Car Stereo Service Bulletin

Model: XR-7070

No. 256

Subject: Schematic Correction: +5V and +9V Lines

CSA-14 Tuner/Tape Deck

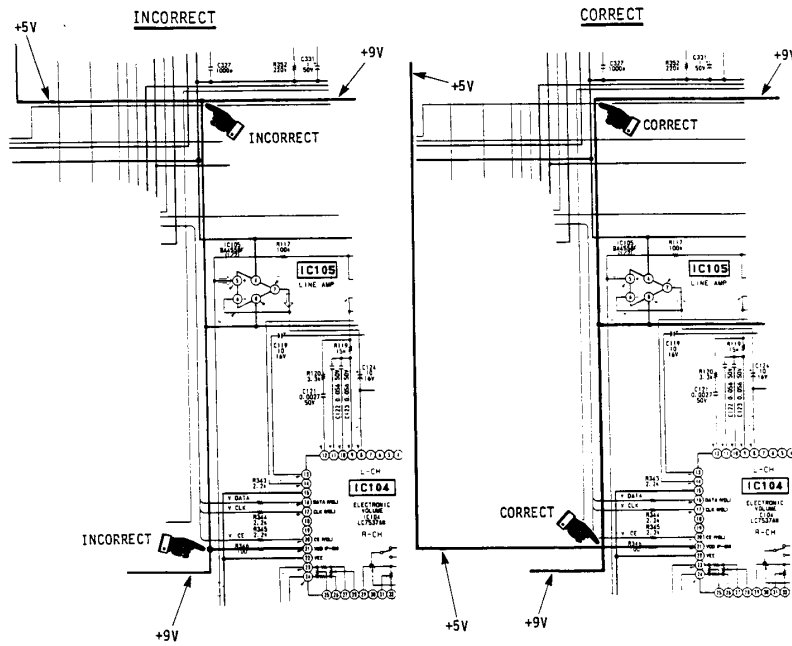
Symptom: (**)
The schematic contains errors with respect to the +5V and +9V lines.

Solution: Correct the schematic in your Service Manual as follows:
